HOMELITE® TECHNICAL SERVICE BULLETIN

NO. 194-001

SUBJECT: OEM "REPOWER" Short Blocks
"Smooth Operator" cylinders and muffler

SUBJECT: PRODUCT IMPROVEMENT

**NEW AIR FILTRATION SYSTEM: CS50 AND 300 CHAIN SAW
CONVERSION KIT A06611**

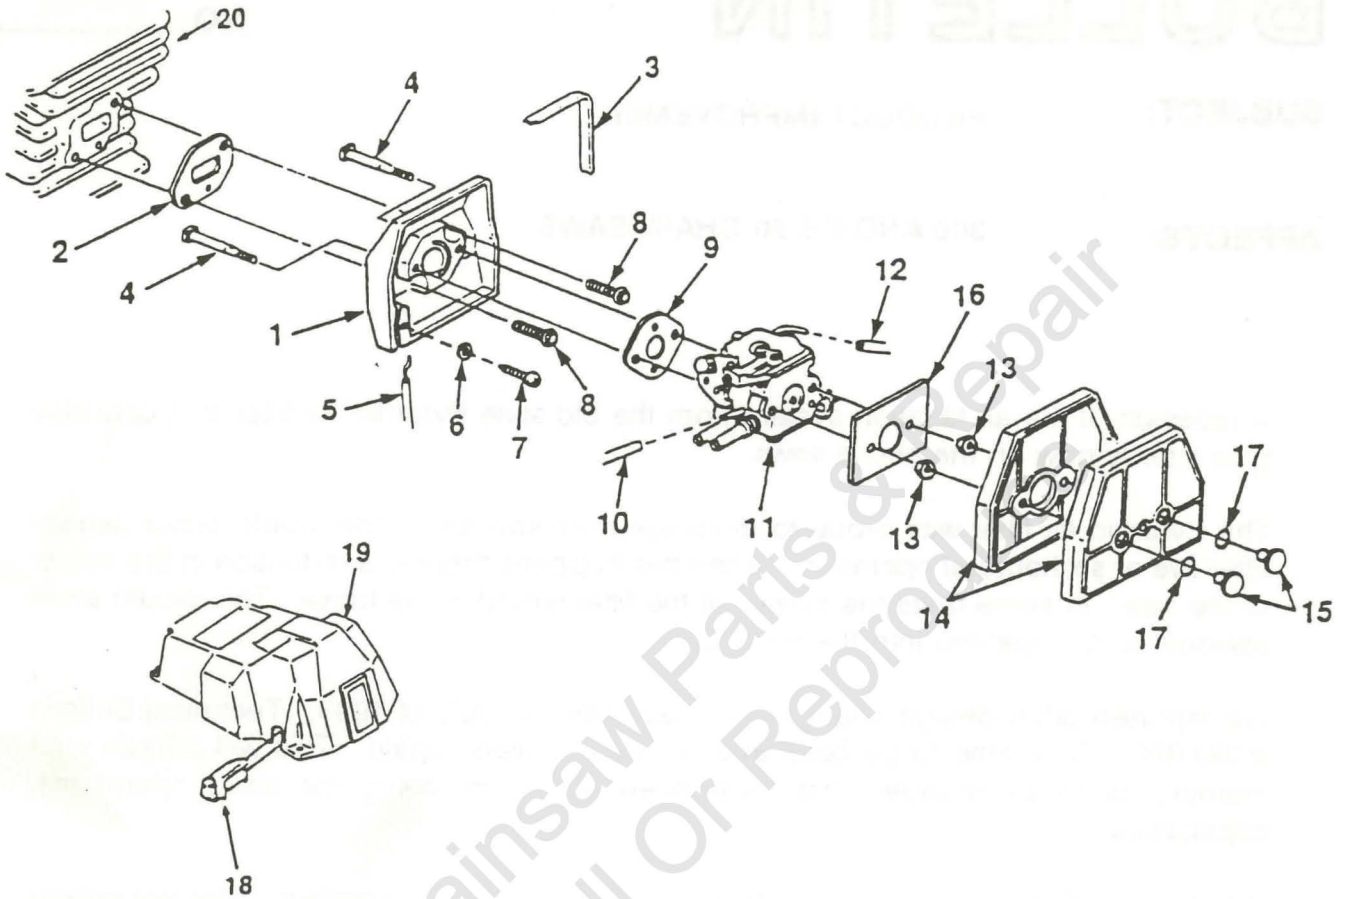
A redesign of the air filtration system from the old style Pyramid air filter to a cartridge type filter is now on the above saws.

The Pyramid air filter was prone to blockage from sawdust. This would occur usually after five or six hours of operation. When this happens there is a reduction in the power of the saw. In some units the corner of the filter would come loose. This would allow sawdust to be ingested into the engine.

With the new filter system, the filter itself has increased filtering surface. This will extend the running time between eighteen to twenty hours before filter maintenance is required.

This change will be on all 300 saws UT10687B. UT10711A beginning with serial number HO2500001. The change on the CS 50 saw UT10710A begins with serial number HO2580001.

If you need to change the piston and cylinder on one of the older units, a new kit, part number A06611 has been made available. A list of the parts included in this kit follows the illustration. ALL of these parts MUST be installed in order to make the proper conversion.

OIL VALVE KITS FOR XL, S2, 180, 192, 200 (A-06386) BANDIT™, LX30 (A-06387)

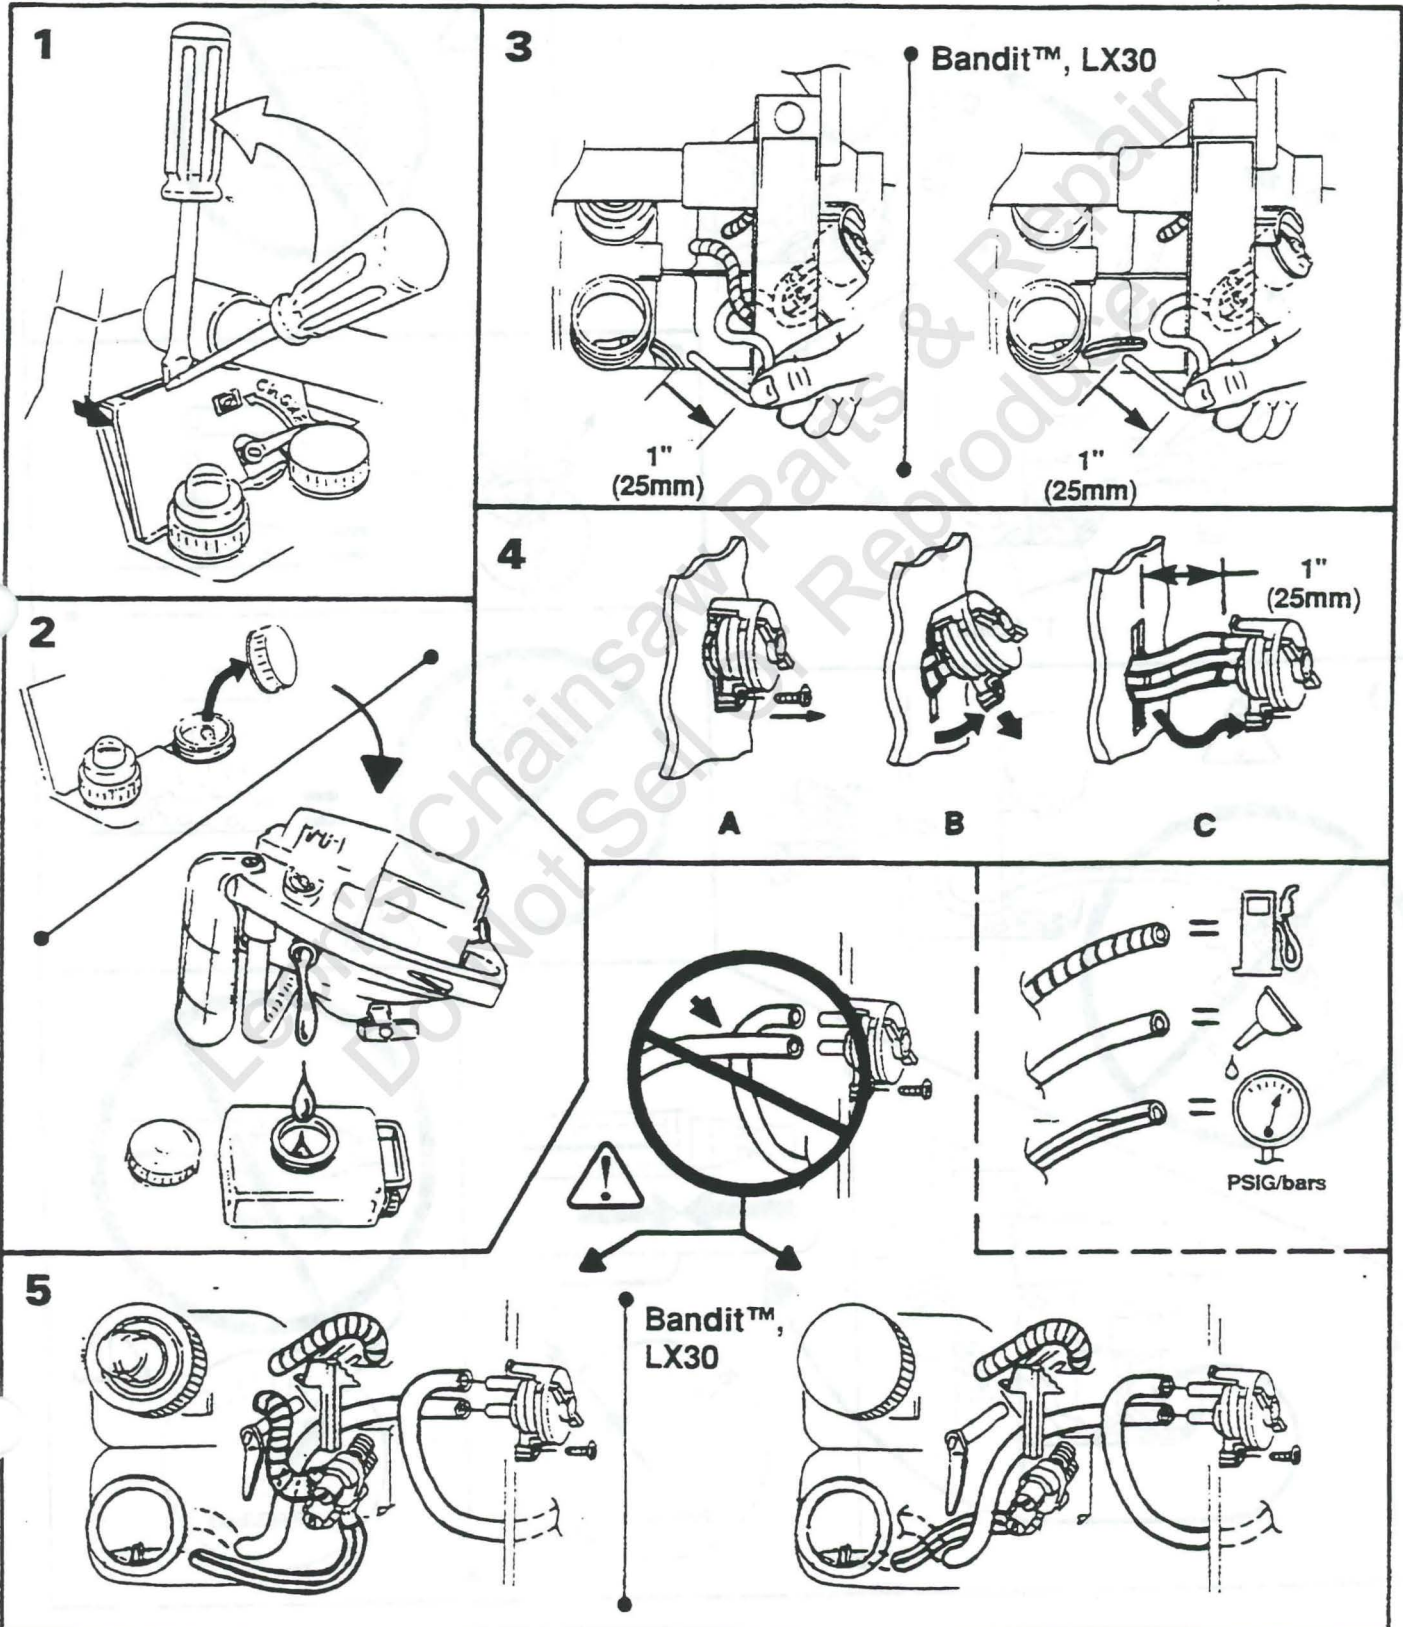
In order to further improve the oiling system on the above saws, a new oil valve is now available.

1. A ball and spring check valve have been added. This will eliminate any siphoning of oil after engine shut down.
2. The cap on the valve has been cut down, and with the lower profile is less likely to be knocked off.

3. The cap retaining legs have been strengthened, and the valve body increased .013 in diameter to provide a tighter fit.
4. The part number for the new valve is:
 - a. XL/200 Family - A06386
 - b. LX-30 Chain Saw - A06387

If you believe that the oiler may not be operating properly, the following quick physical inspection can help you find the problem. A visual work sheet has been included with this bulletin. By following the instructions below and referring to this sheet, you will find that checking the oil system or replacing the oil valve is quite simple.

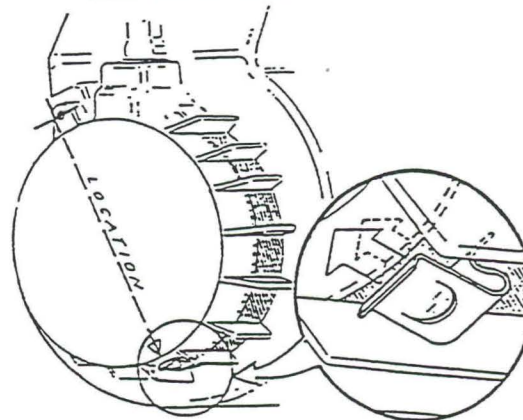
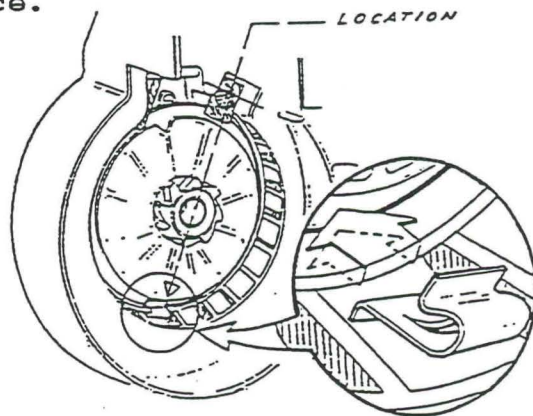
Beginning in mid 1993 starter housings for 25 and 30cc products were redesigned and manufactured to include two starter pulley hold down retainers. At the same time, we have also developed a clip that will add the second retention point to units produced prior to the housing change. Twenty five (25) clips are included in each package. We recommend that the clip be used on all units produced without the improved starter housings. Below are instructions for installation. This improvement to the starter housing eliminates the possibility of the starter pulley cocking causing the rewind spring to loose tension.

Note: Clip has a long side and a short side; when installed the long side is outside the starter housing.

String trimmers and AP125:
From outside of housing, hold clip with needle nose pliers using screw driver as lever, push down.

MudBuster: turn unit over, starter can be accessed through square hole in the center of the base. With pliers insert clip through the square hole in starter housing (second from post) Using screw driver as a lever push the clip in place.

Figure 1

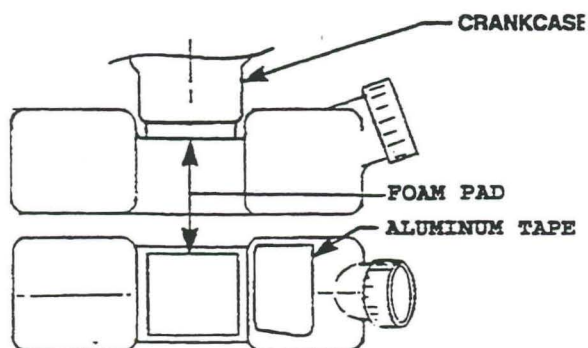
Under certain conditions of extremely high ambient temperatures (95 deg. F and higher), fuel may "boil" in the fuel tank causing gases to accumulate inside the tank. Because there is no vent in the tank that allows the gases to escape (the valve in the cap only allows air into the tank), pressure may eventually build high enough inside the tank to cause the tank to swell and contact the lower surface of the crankcase. If the tank contacts the crankcase for prolonged periods, it may melt at the contact point.

To prevent this from occurring a heat deflector kit, A07077 has been made available. The kit consists of two parts, foam pad, part number 07074, and aluminum tape, part number 95615. Install the parts as shown in figure 1. Before installing the aluminum tape make sure the surface of the fuel tank is clean and free of oil film. **NOTE:** When reinstalling the crankcase cover make sure the foam pad is not pinched between the crankcase and crankcase cover. When reinstalling the starter, rotate 90 degrees from its original position and install as shown in figure 2.

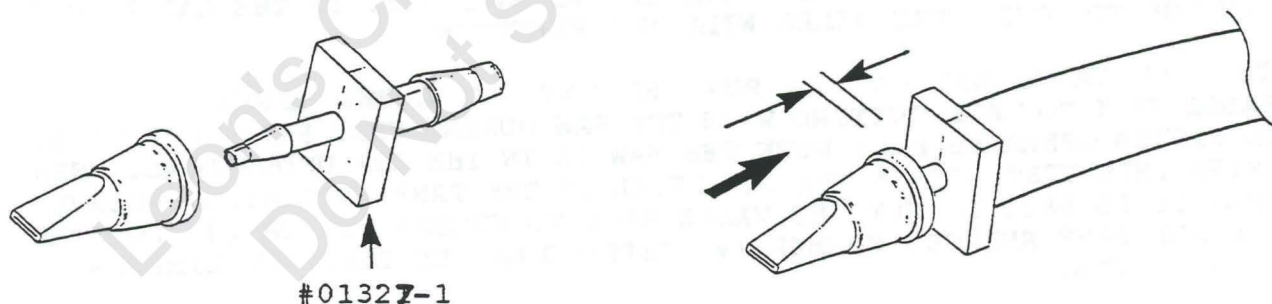
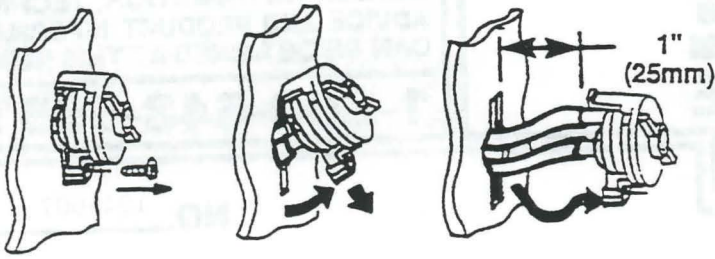
CURRENT PRODUCTION OF AFFECTED MODEL SAWS ARE NOW BUILT WITH A MODIFIED CHAIN OILER VALVE AND CONNECTOR. THESE WILL INCREASE THE FLOW CALIBRATION RATE TO THE GUIDE BAR AND CHAIN. IF A CUSTOMER IS COMPLAINING OF INSUFFICIENT OIL FLOW. YOU MAY SERVICE THE OLD STYLE OILER BY USING THESE COMPONENTS. IN MOST CASES YOU WILL FIND THAT BY CHANGING ONLY THE CONNECTOR AND USING THE EXISTING VALVE THE OIL FLOW WILL INCREASE SUBSTANTIALLY. IT IS NOT NECESSARY TO CHANGE BOTH ITEMS IN ORDER TO CORRECT AN INSUFFICIENT OILING COMPLAINT.

REMOVE THE CONNECTOR (69659B) AND WASHER (83024) FROM BETWEEN THE DUCKBILL VALVE AND CRANKCASE PRESSURE LINE AND INSTALL THE NEW CONNECTOR (01327-1) SHOWN BELOW TO CONNECT THE DUCKBILL AND THE PRESSURE LINE. WHEN INSTALLING THIS CONNECTOR MAKE SURE THE DUCKBILL IS PLACED ON THE SMALLER OF THE TWO BARBS (SEE ILLUSTRATION) AND IS PUSHED ON OVER THE BARB UNTIL IT SNAPS IN PLACE. **DO NO PUSH IT ALL THE WAY AGAINST THE SQUARE PART OF THE CONNECTOR.** IF IT IS PUSHED ALL THE WAY ON, THE BARB MAY REACH TOO FAR INTO THE DUCKBILL HOLDING IT OPEN, KEEPING IT FROM FUNCTIONING PROPERLY.

IN ORDER TO REPLACE THE OIL VALVE WITH THE NEW VALVE (A06386A). REMOVE THE SMALL SCREW UNDER THE VALVE. LIFT THE BOTTOM OF THE VALVE OUT AND UP. THERE SHOULD BE ABOUT 1" OF LINE COMING OUT OF THE HOUSING. IF NOT, PULL A SMALL AMOUNT OF LINE OUT OF THE TANK TO GIVE YOU ROOM TO WORK. FOLLOW THE ILLUSTRATION ON THE BACK PAGE IN ORDER TO CONNECT THE LINES AND ROUTE THEM PROPERLY. REVERSE THE PROCEDURE YOU USED TO REMOVE THE VALVE, TO PUT IT BACK IN THE HOUSING. YOU MAY HAVE TO HOOK THE OIL LINE WITH THE PICKUP ON IT OUT OF THE TANK WHEN YOU ARE FINISHED. MAKE SURE YOU PULL ENOUGH LINE BACK INTO THE TANK TO REMOVE ANY KINKS THAT HAVE FORMED. SIMILARLY TAKE CARE TO PREVENT KINKS IN THE LINE TO THE GUIDE BAR.

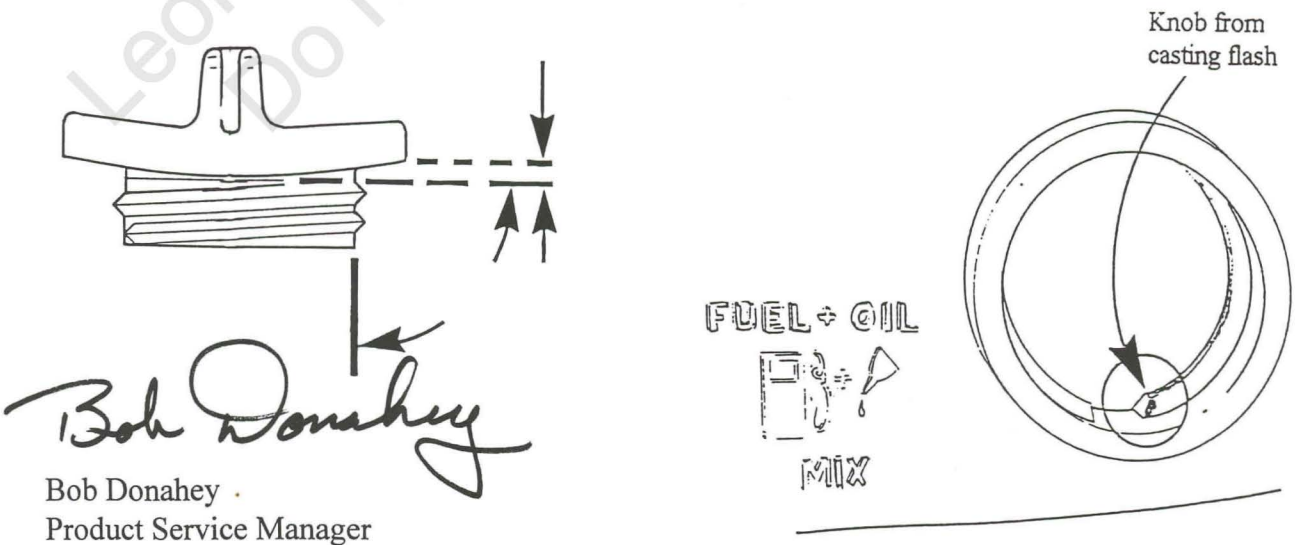
If you receive a complaint of a leaking fuel tank on one of the affected saws, you can be assured that it is probably leaking at the cap. There are two things that can cause fuel to leak around the cap on these units, both are easily corrected.

- 1) Remove the fuel cap, and check for flash on the threads of the tank. Refer to the illustration below for the exact location. You will notice at the bottom of the thread there may be a small knob (dark spot on illustration, see arrow). Using a small file or some other fine edged instrument remove the flash. **THIS AREA HAS BEEN PAINTED AND IT MAY NOT BE EASY TO SEE THE FLASH.**

- 2) The sealing surface of the cap may be warped (see illustration). We are presently machining the cap (A03131) to insure that we have a perfectly flat surface. Reworked caps are available in inventory, or you may request that caps be sent to you by calling a Dealer Service Representatives at (800) - 648 - 8951, then press 3.
